Access Compliance Report

Public Rights-of-Way

Intersection ID: 49655	Main Street: GREENWAY_CRESCENT_LN	Cross Street: SEIGLE_POINT_DR	Location:	N
ADA ID: F63CCB67E2AB	Ramp Type: Directional1	Initial Pass/Fail: Pass	Overall Compliance: No	Severity Score: 7.5
Codes/Mitigation Info/Possible Solution		Field Measurements/Component Compliance

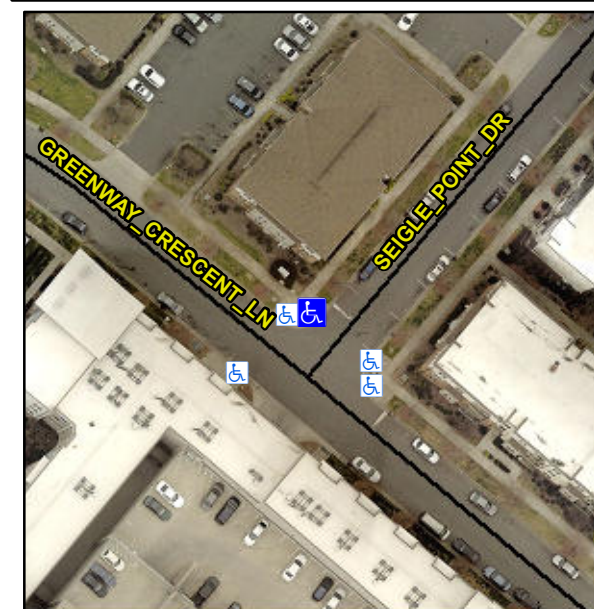
**Remove & Replace Entire Ramp.
Grind Gutter Lip.**

R304.5.3, R302.7, R302.7.2
